Changes to proposed District Map Amendment G-956

On May 2, the Planning Board transmitted to the County Council proposed Zoning Text Amendment (ZTA) 13-04, Zoning Ordinance – Revised, and District Map Amendment (DMA) G-956. DMA G-956 was introduced to implement the new zoning ordinance.

A revised version of DMA G-956, dated October 11, 2013, has been posted on the Planning Department website for review. It contains all of the proposed and approved changes that have occurred since August 30, 2013. The following document illustrates all of the changes to DMA G-956.

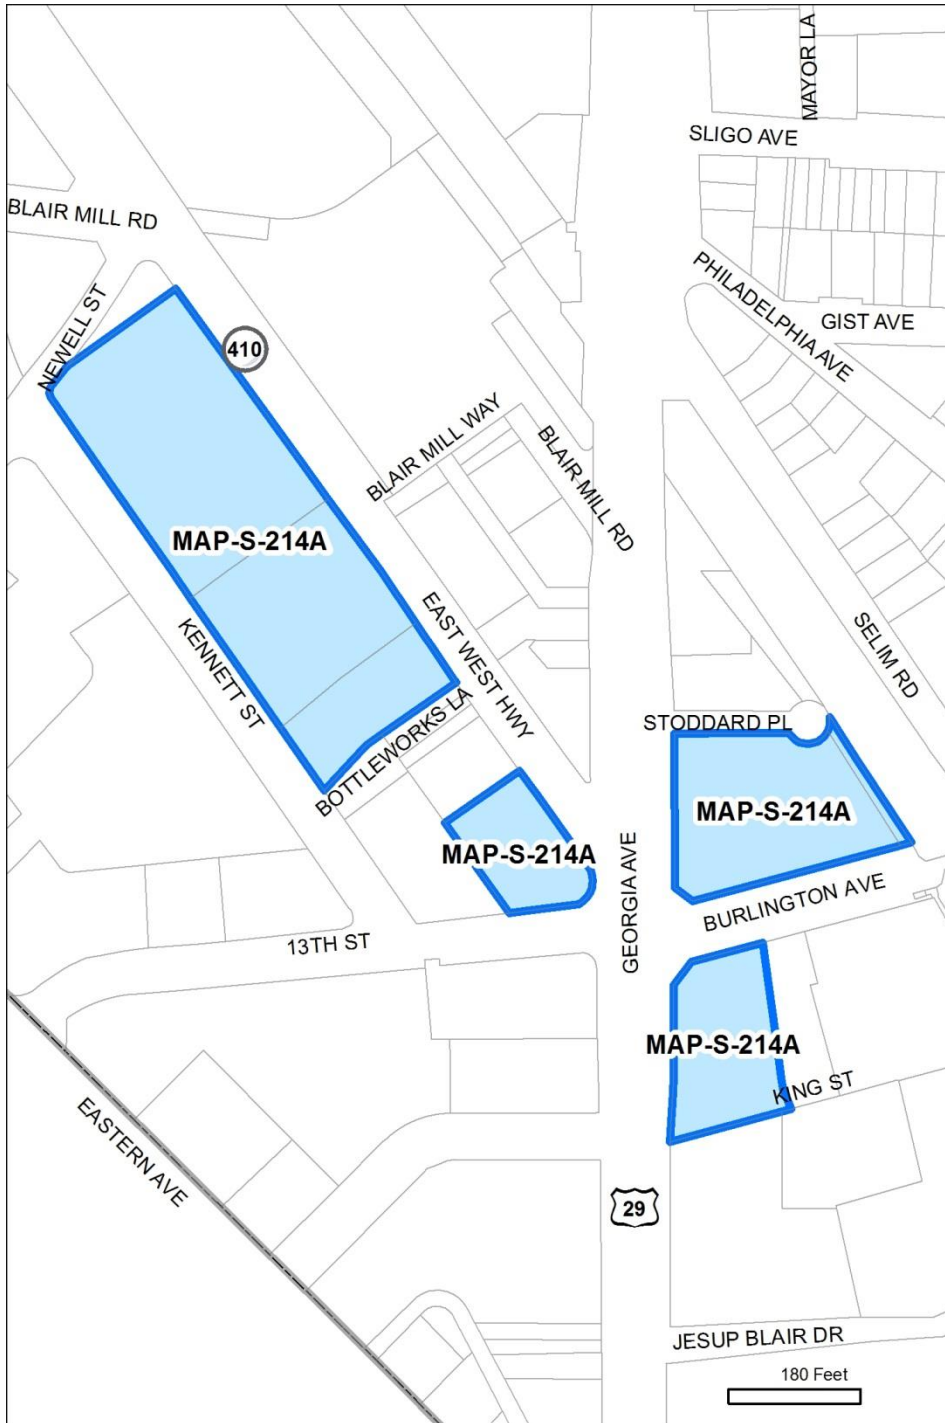
Unique ID: MAP-S-202		staff recommendation
Master Plan ID: n/a		
Master Plan:	Upper Rock Creek	
Location:	Olney-Laytonsville Road @ Brookeville Rd	
Existing Zone:	C-4	
Proposed Conv: (8/31)	CRT-0.25 C-0.25 R-0.25 H-30	
Prop. Revised Conv:	CRT-0.25 C-0.25 R-0.25 H-35	
Category:	Staff Recommendation	
Modifications	Zone Group:	No change
	Overall FAR:	No change
	Comm'l FAR:	No change
	Resid'l FAR:	No change
	Height:	Increased to 35'
Reason for change:		
<p>The C-4 zone currently allows development to heights up to 30', except when sites meet certain conditions that this site does not meet.</p> <p>The Planning Staff recommended that the C-4 zone be translated to the CRN zone with a height of 30 feet, however the Planning Board recommended changing this to CRT to better accommodate currently allowed uses.</p> <p>Staff made the change to CRT without changing any of the densities or heights.</p> <p>However, the CRT as currently written and as proposed does not allow a maximum height to be set lower than 35 feet, so the conversion proposed on 5/2 and 8/31 is not allowed under either the current or proposed ordinance.</p> <p>Therefore, Planning Staff recommends changing the proposed conversion for the C-4 zone when recommended for lower intensity to CRT-0.25 C-0.25 R-0.25 H-35.</p> <p>This site is the only place in the county where that conversion is proposed.</p>

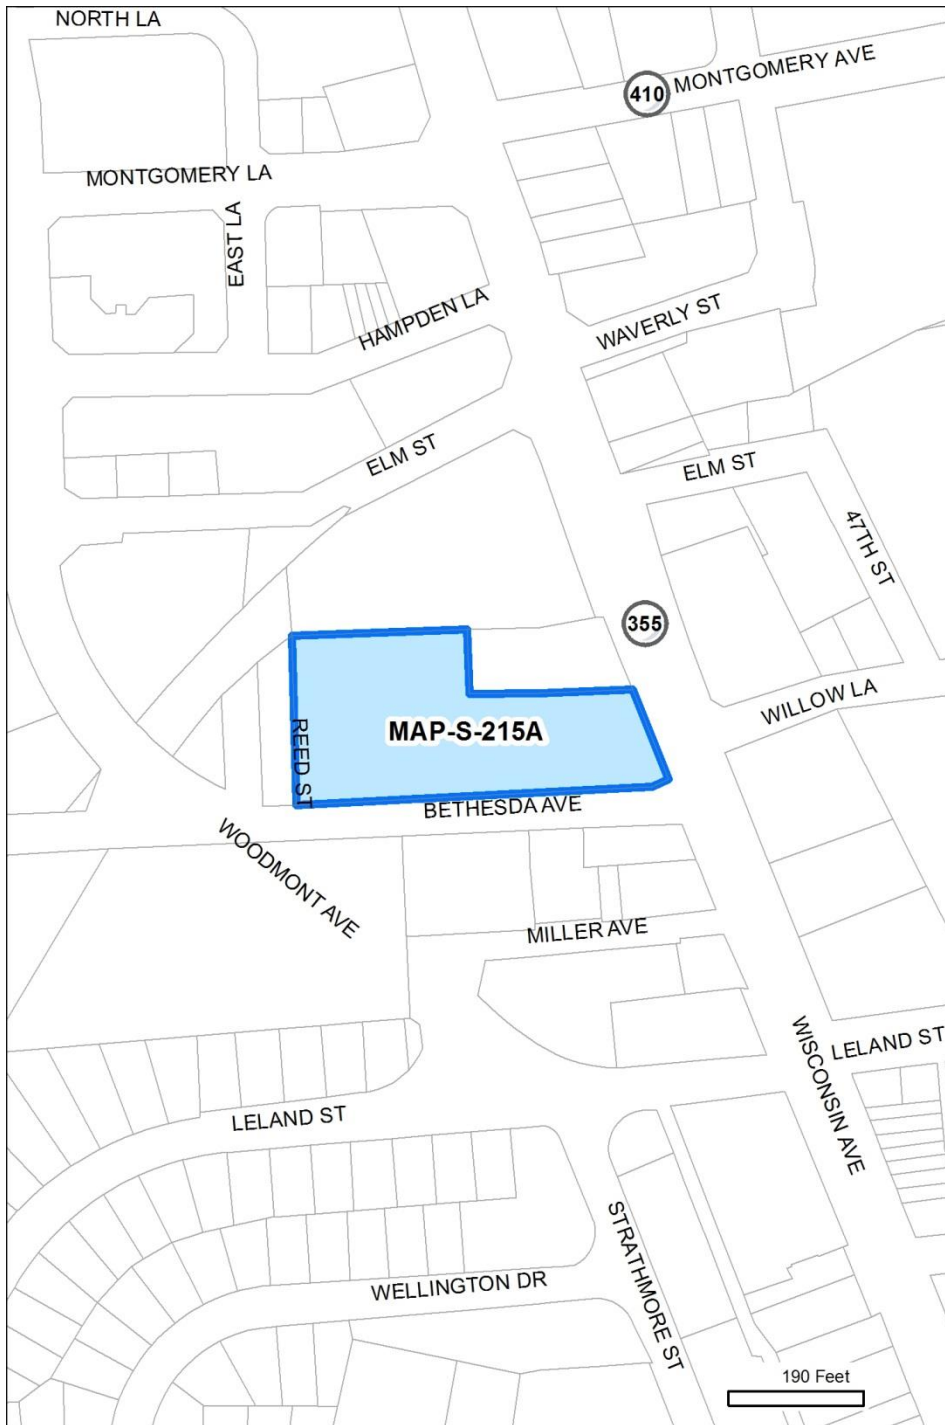
Unique ID: MAP-S-214A		staff rec. change
Master Plan ID: n/a		
Master Plan:		Silver Spring CBD
Location:		South Silver Spring
Existing Zone:		CBD-1
Proposed Conv: (8/31)		CR-3.0 C-3.0 R-2.5 H-90 T
Prop. Revised Conv:		CR-3.0 C-2.0 R-2.75 H-90 T
Category:		Staff Recommended Change
Modifications	Zone Group:	No change
	Overall FAR:	No change
	Comm'l FAR:	Reduced to 2.0
	Resid'l FAR:	Increased to 2.75
	Height:	No change
Reason for change:		
<p><i>In the current zoning ordinance, properties in the CBD zones meeting certain criteria can develop with an increased non-residential FAR. These properties met the criteria, and in the 5/2 and 8/31 conversions were given the additional commercial FAR in their formulas. However, Planning Staff recommended, and the PHED Committee agreed to change this conversion.</i></p> <p><i>The current ordinance requires that the additional commercial FAR be given only for projects including a lodging use and ground-floor retail. However, these uses would not be guaranteed under the new CR zoning.</i></p> <p><i>Instead, the PHED Committee recommends giving the additional commercial FAR only where sites meet the criteria in the current ordinance and where the Planning Board has already approved such an increase in density.</i></p> <p><i>Additionally, granting 2.75 in residential FAR gives a better approximation of the currently permitted residential density.</i></p> <p><i>Therefore, these properties are proposed to be translated using the standard conversion for CBD-1 to CR-3.0 C-2.0 R-2.75 H-90 T.</i></p>

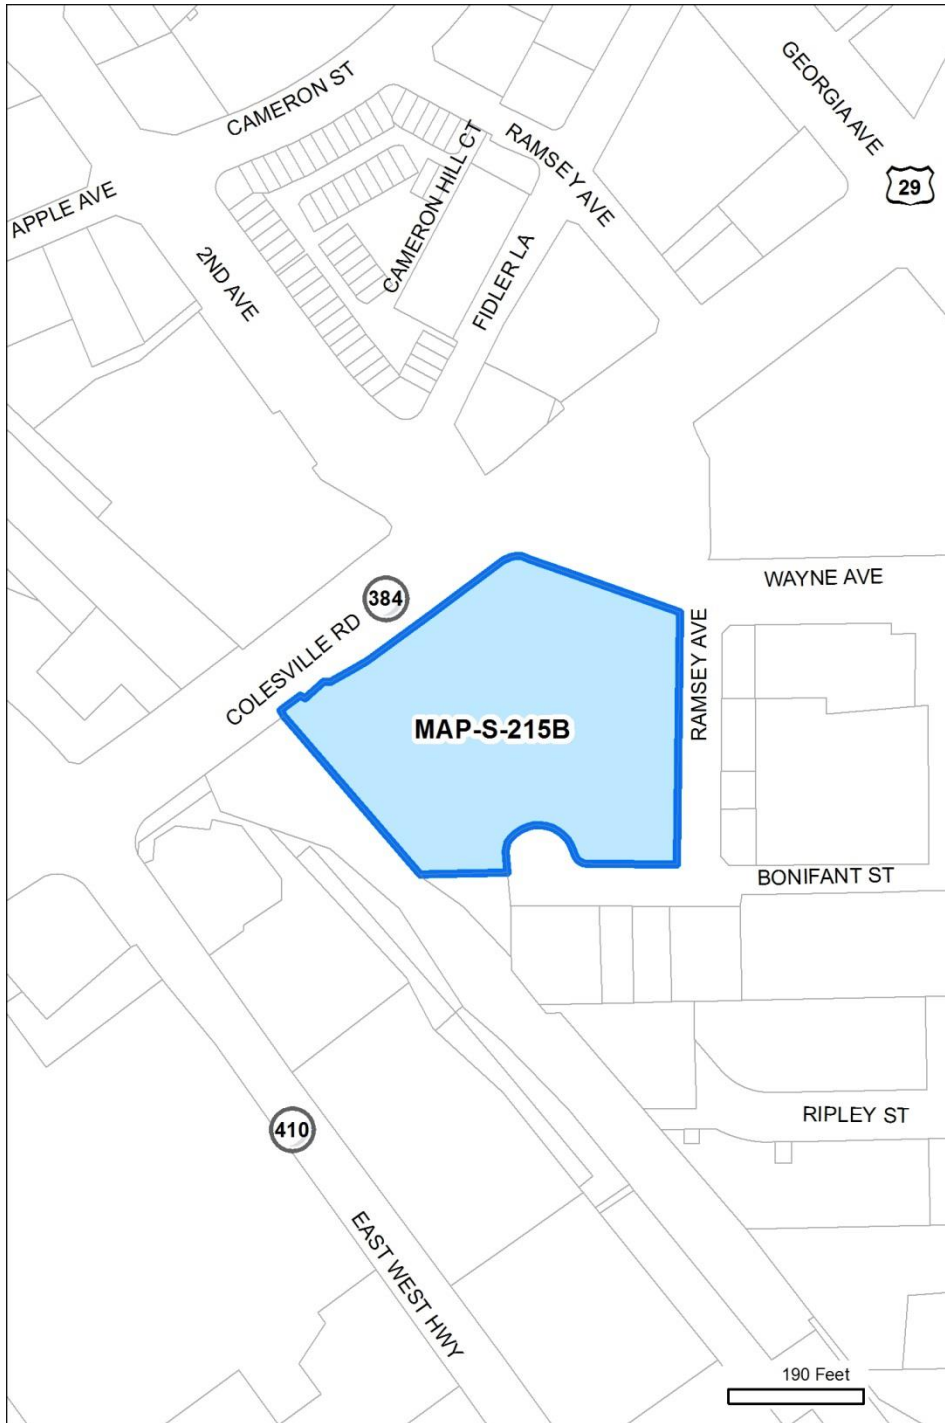
Unique ID: MAP-S-215A		staff rec. change
Master Plan ID: n/a		
Master Plan:		Bethesda CBD
Location:		North side Bethesda Av west of Wisconsin
Existing Zone:		CBD-2
Proposed Conv: (8/31)		CR-5.0 C-5.0 R-4.5 H-145 T
Prop. Revised Conv:		CR-5.0 C-4.0 R-4.75 H-145 T
Category:		Staff Recommended Change
Modifications	Zone Group:	No change
	Overall FAR:	No change
	Comm'l FAR:	Reduced to 4.0
	Resid'l FAR:	Increased to 4.75
	Height:	No change
Reason for change:		
<p><i>In the current zoning ordinance, properties in the CBD zones meeting certain criteria can develop with an increased non-residential FAR. These properties met the criteria, and in the 5/2 and 8/31 conversions were given the additional commercial FAR in their formulas. However, Planning Staff recommended, and the PHED Committee agreed to change this conversion.</i></p> <p><i>The current ordinance requires that the additional commercial FAR be given only for projects including a lodging use and ground-floor retail. However, these uses would not be guaranteed under the new CR zoning.</i></p> <p><i>Instead, the PHED Committee recommends giving the additional commercial FAR only where sites meet the criteria in the current ordinance and where the Planning Board has already approved such an increase in density.</i></p> <p><i>Additionally, granting 4.75 in residential FAR gives a better approximation of the currently permitted residential density.</i></p> <p><i>Therefore, these properties are proposed to be translated using the standard conversion for CBD-2 to CR-5.0 C-4.0 R-4.75 H-145 T.</i></p>

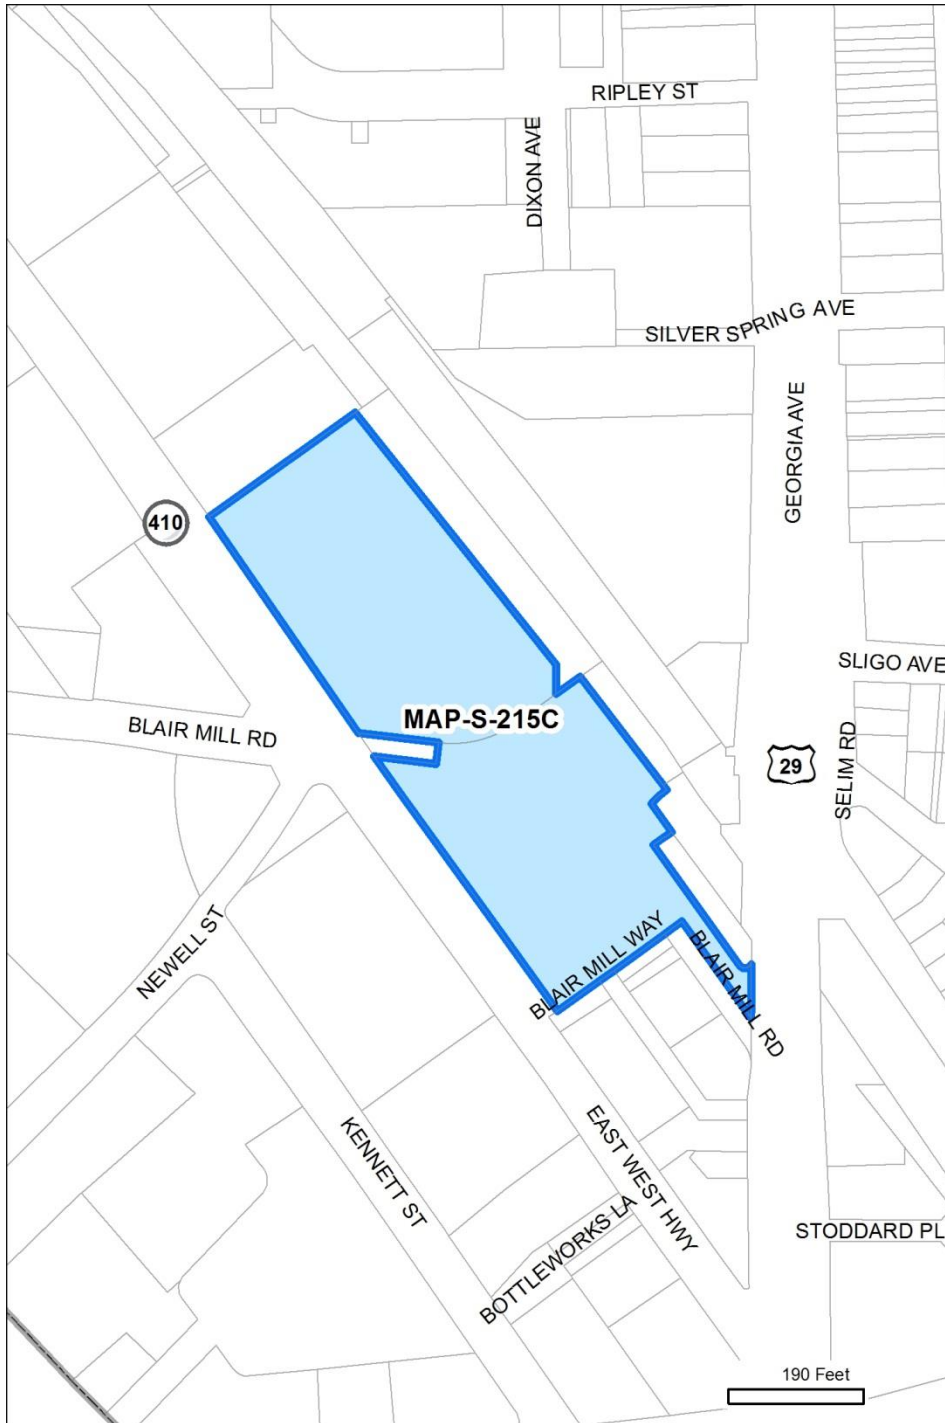
Unique ID: MAP-S-215B		staff rec. change
Master Plan ID: n/a		
Master Plan:		Silver Spring CBD
Location:		Silver Spring Transit Center site
Existing Zone:		CBD-2
Proposed Conv: (8/31)		CR-5.0 C-5.0 R-4.5 H-145 T
Prop. Revised Conv:		CR-5.0 C-4.0 R-4.75 H-145 T
Category:		Staff Recommended Change
Modifications	Zone Group:	No change
	Overall FAR:	No change
	Comm'l FAR:	Reduced to 4.0
	Resid'l FAR:	Increased to 4.75
	Height:	No change
Reason for change:		
<p><i>In the current zoning ordinance, properties in the CBD zones meeting certain criteria can develop with an increased non-residential FAR. These properties met the criteria, and in the 5/2 and 8/31 conversions were given the additional commercial FAR in their formulas. However, Planning Staff recommended, and the PHED Committee agreed to change this conversion.</i></p> <p><i>The current ordinance requires that the additional commercial FAR be given only for projects including a lodging use and ground-floor retail. However, these uses would not be guaranteed under the new CR zoning.</i></p> <p><i>Instead, the PHED Committee recommends giving the additional commercial FAR only where sites meet the criteria in the current ordinance and where the Planning Board has already approved such an increase in density.</i></p> <p><i>Additionally, granting 4.75 in residential FAR gives a better approximation of the currently permitted residential density.</i></p> <p><i>Therefore, these properties are proposed to be translated using the standard conversion for CBD-2 to CR-5.0 C-4.0 R-4.75 H-145 T.</i></p>
